ADDENDUM NO. 1

DATE OF ISSUANCE: April 12, 2024

PROJECT: 2024 Addition and Renovations
North Harrison Elementary School
1115 W. Whiskey Run Road
Ramsey, IN 47166

ARCHITECT'S PROJECT NO.: 23-228.001

ROOF PLAN
1/8" = 1'-0"

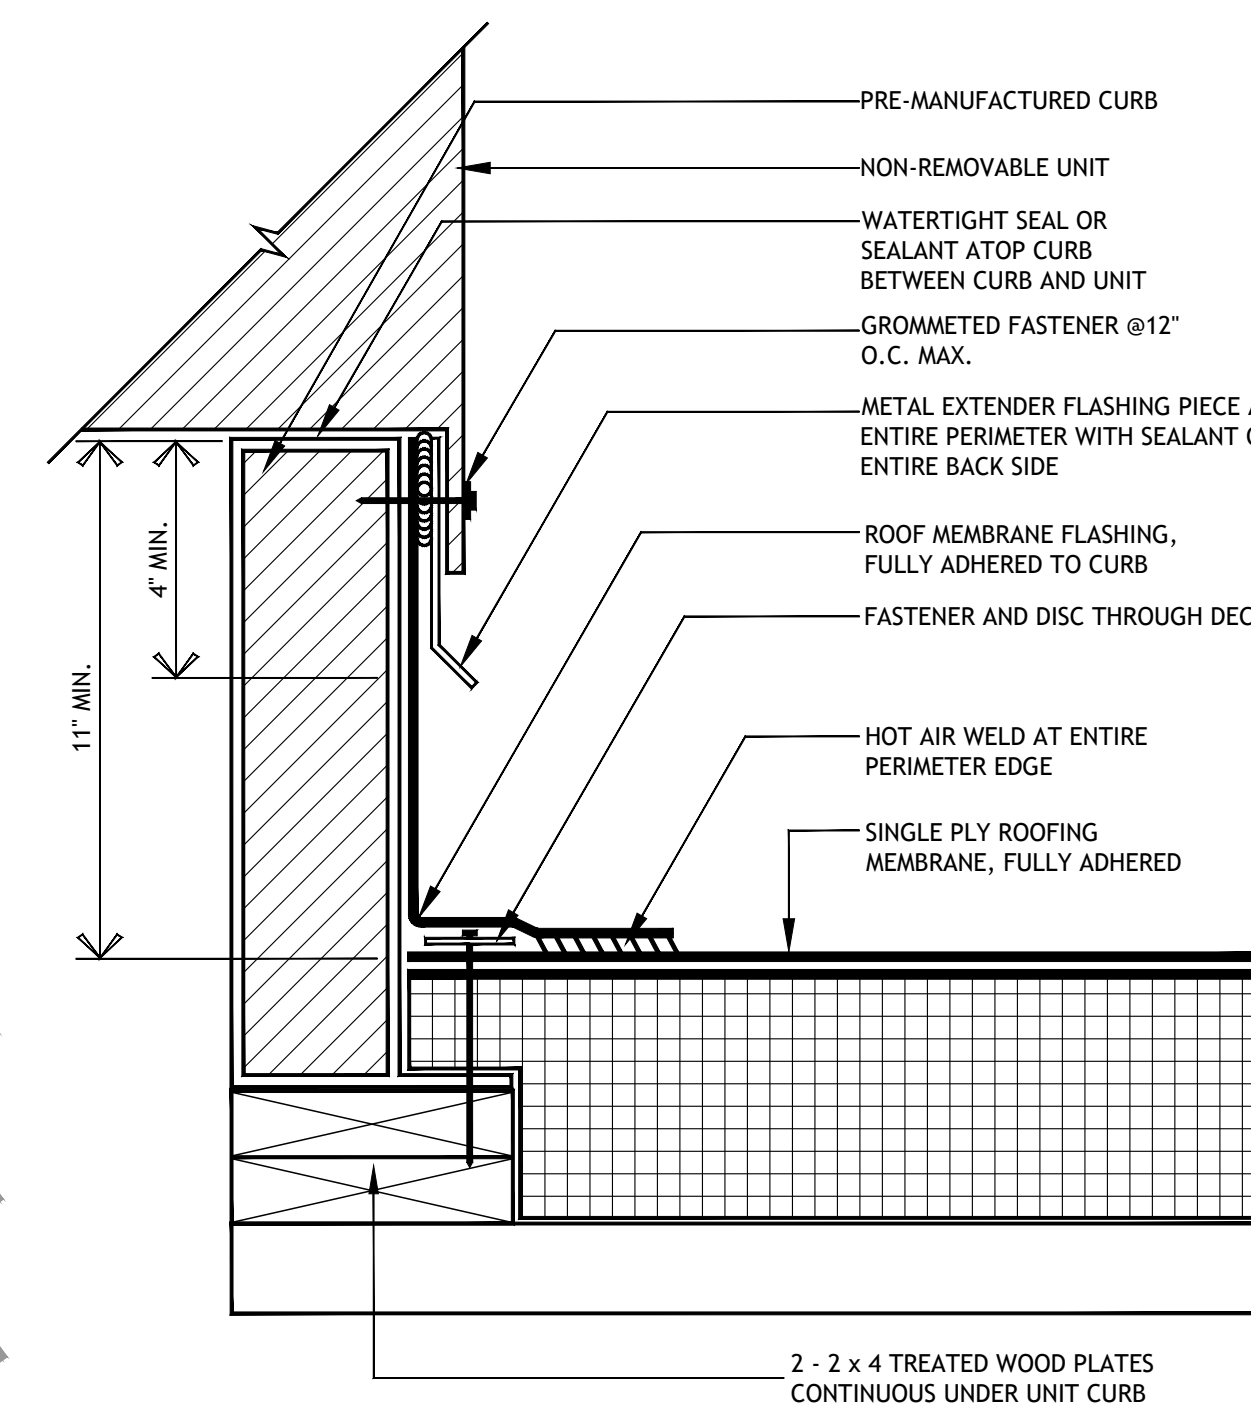
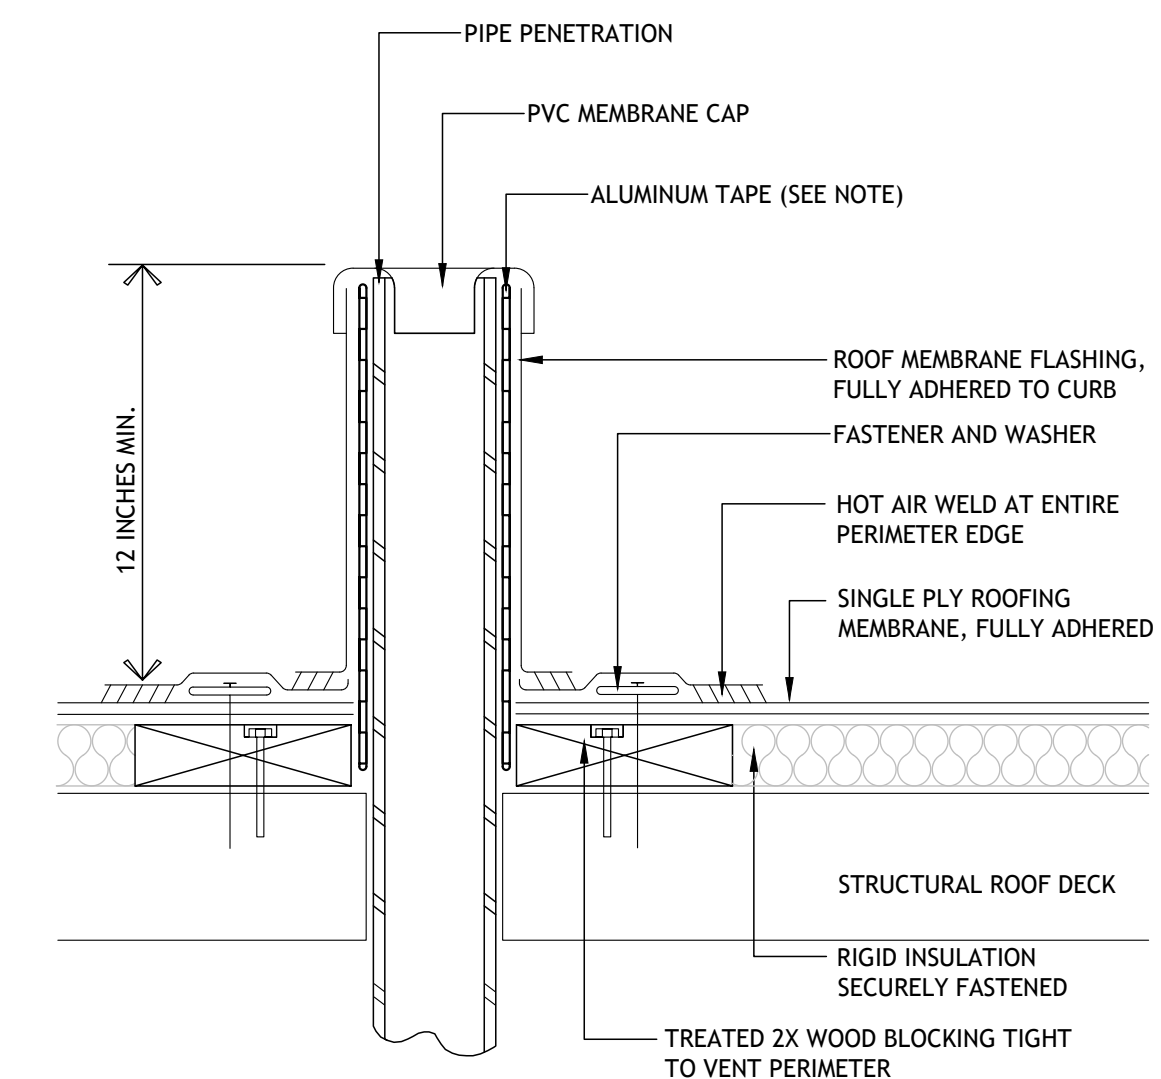
CHANGES TO DRAWINGS**ADD-1 Item No. D-1 - Roof Plan**

Refer to Sheet(s): **A301**

Replace with attached revised Drawing in its entirety; revisions have been clouded for reference.

SHEET TITLE
FOOD SERVICE DEMOLITION PLAN

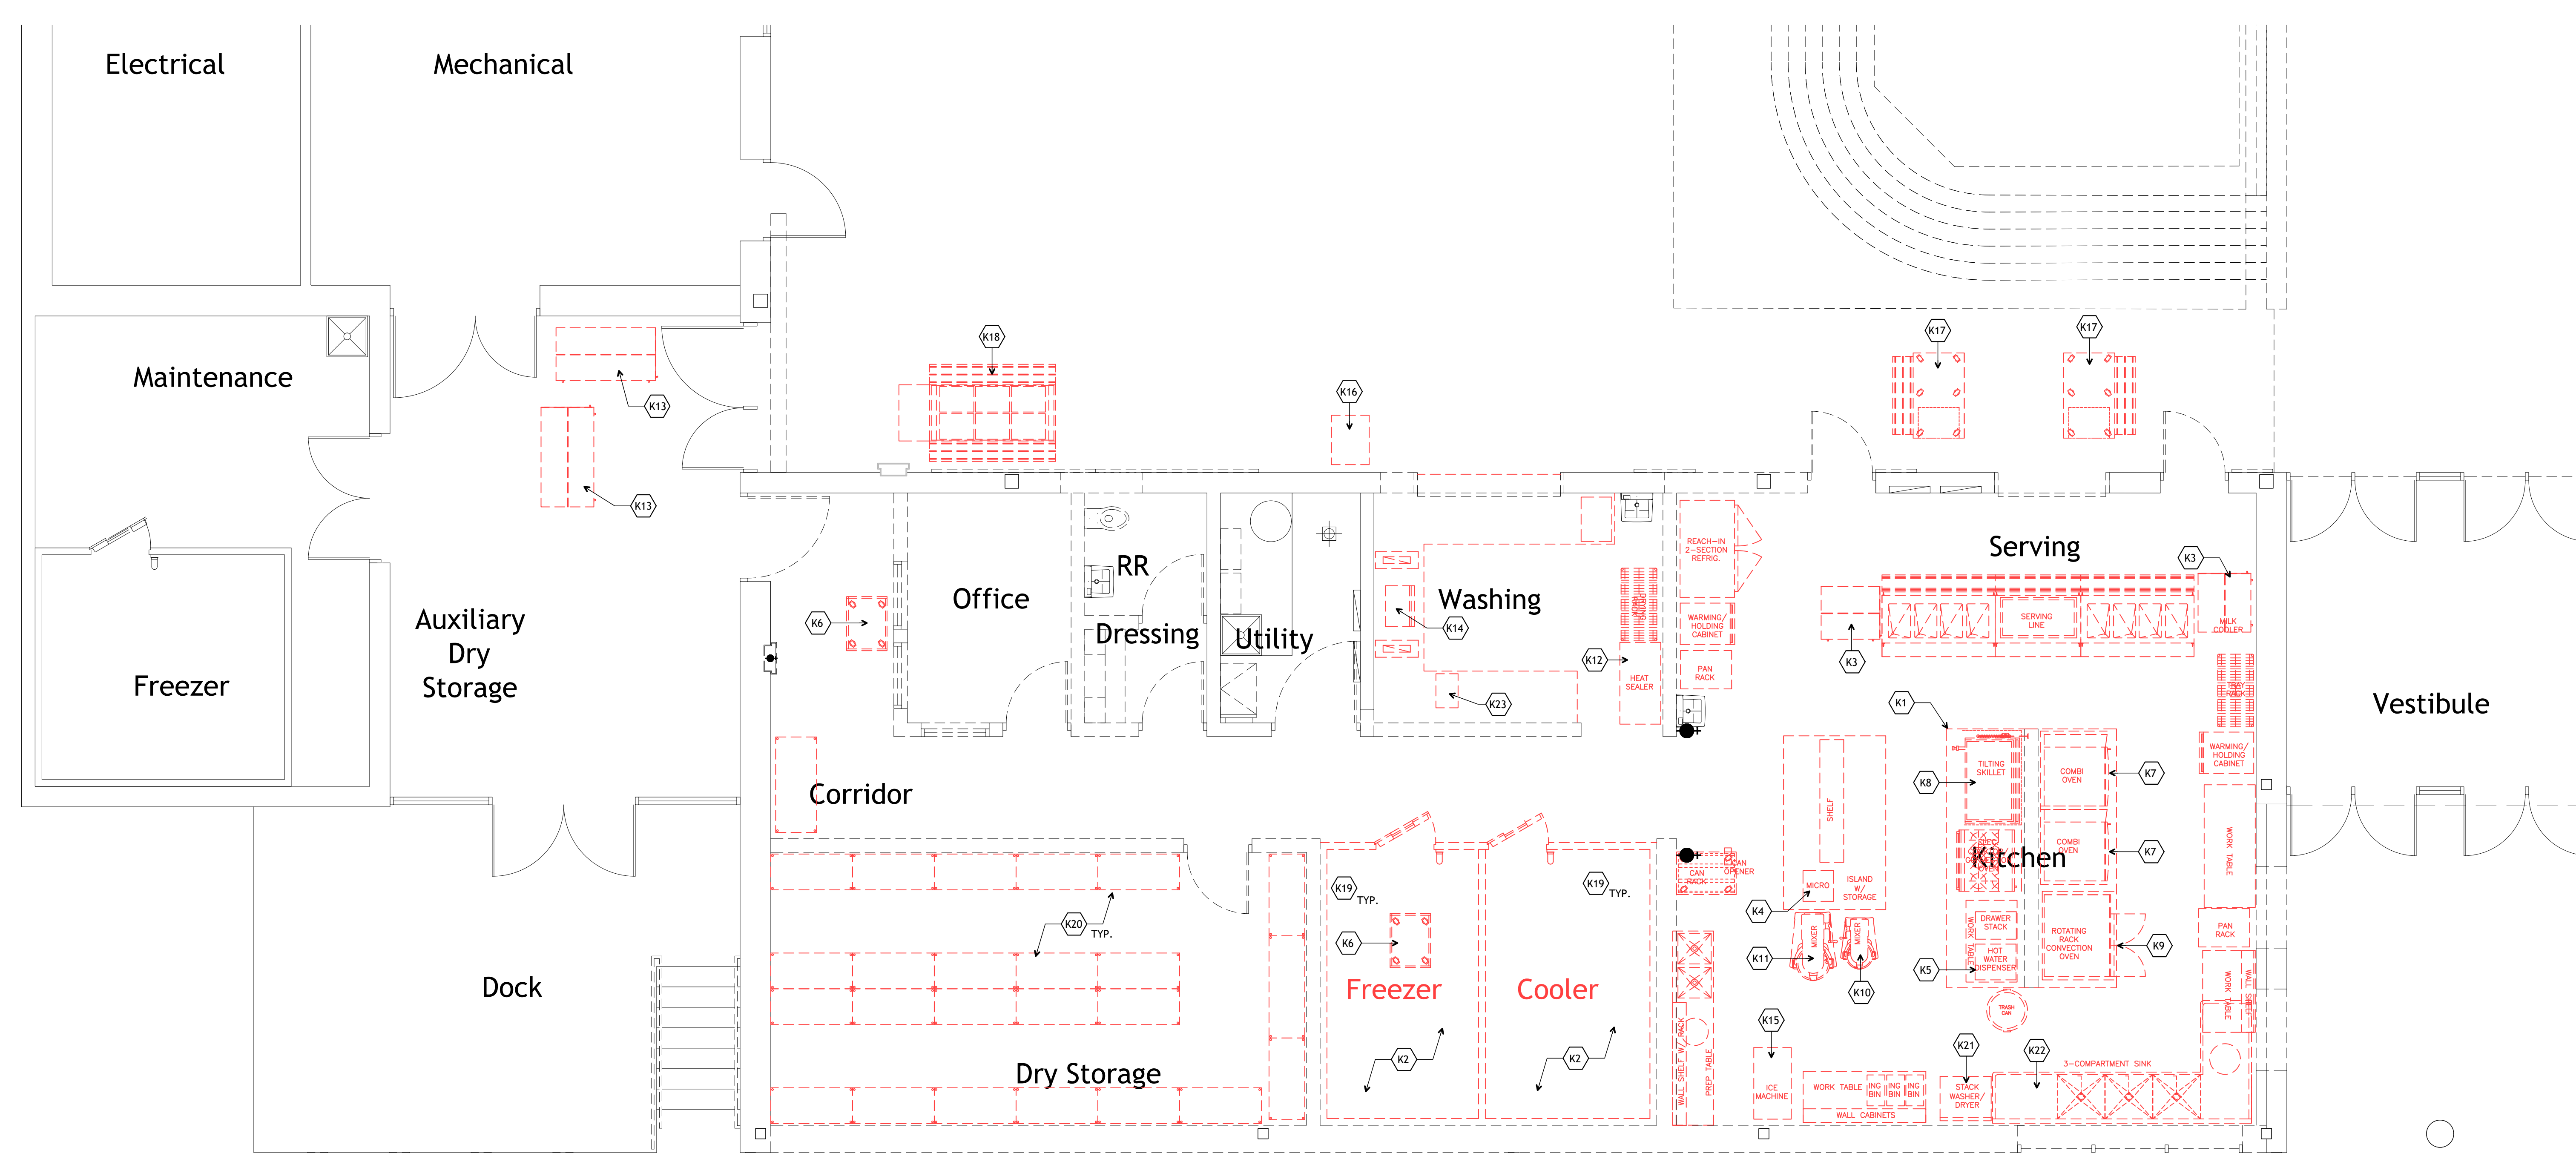
ADD-1 Item No. D-2 - Kitchen Demolition Plan

Refer to Sheet(s): K001

Add attached Drawing in its entirety.

SHEET TITLE
PLUMBING LEGEND, GENERAL NOTES, SCHEDULES
AND DETAILS
SHEET NUMBER
P100
DATE
APRIL 3, 2024

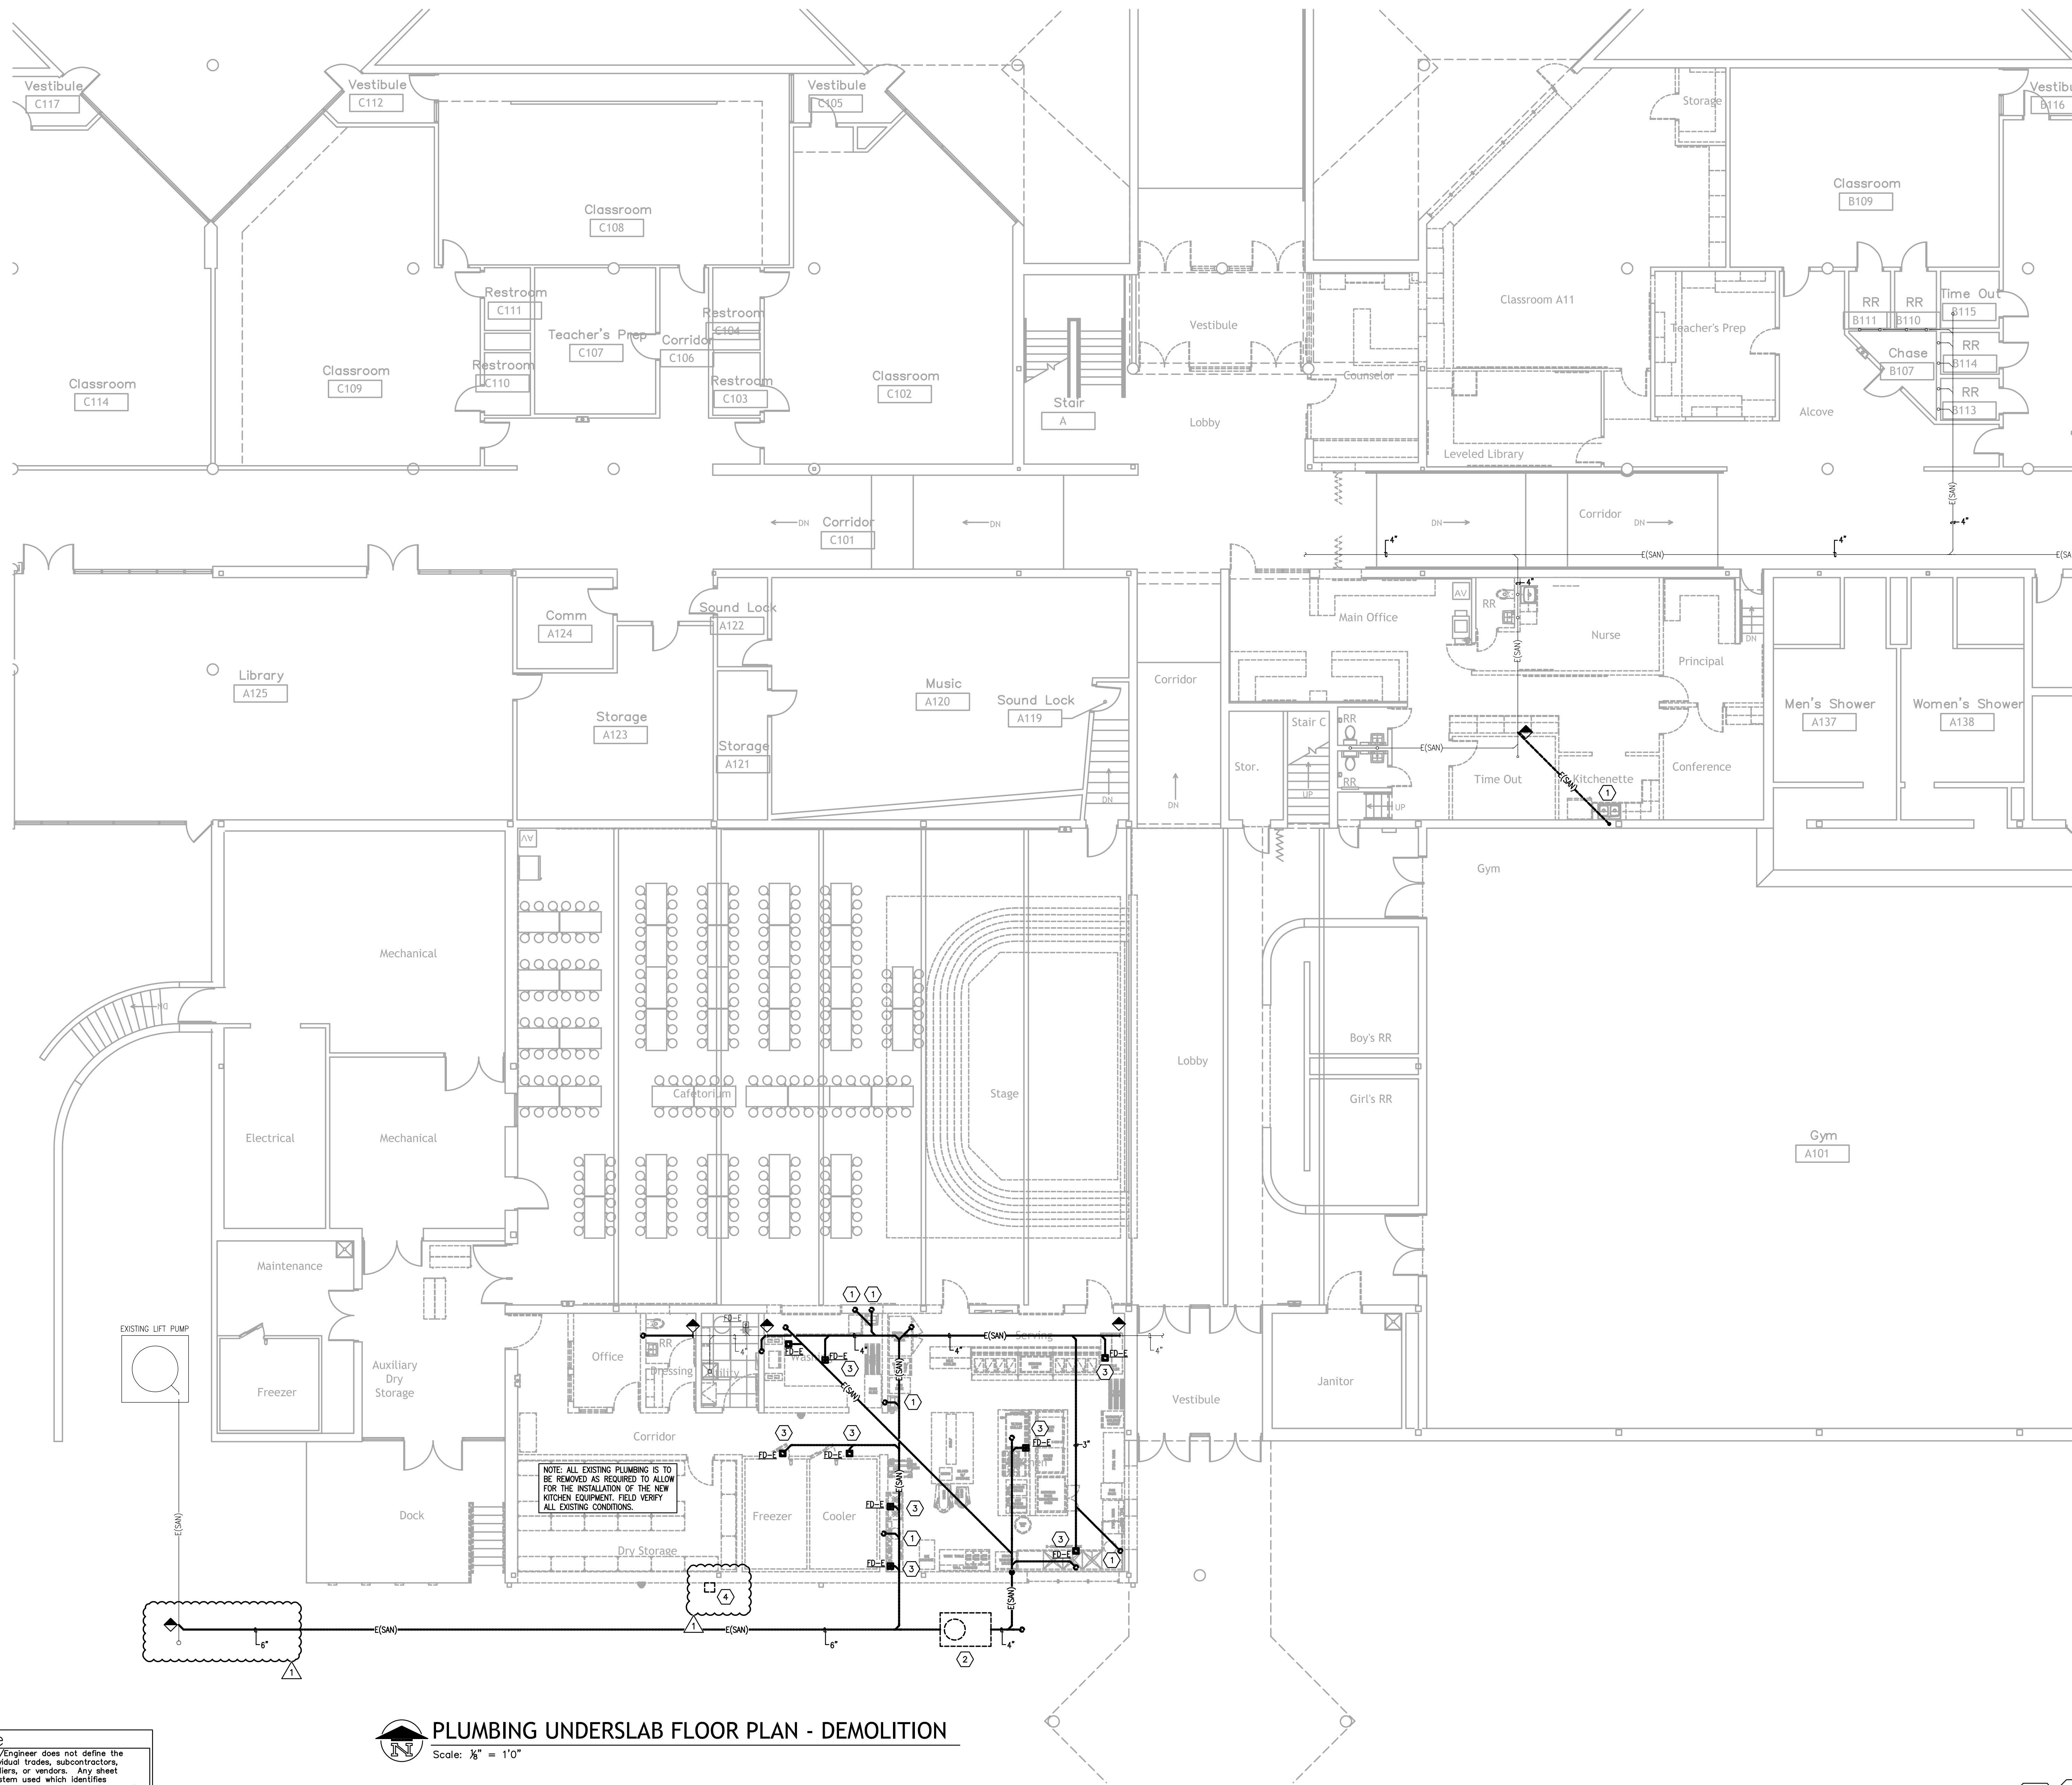
ADD-1 Item No. D-5 - Plumbing Legend, general Notes, Schedules, and Details

Refer to Sheet(s): P100

- Replace with attached revised Drawing in its entirety; revisions have been clouded for reference.
- Plumbing details have been added.
- The natural gas loads have been added for the new gas meter.
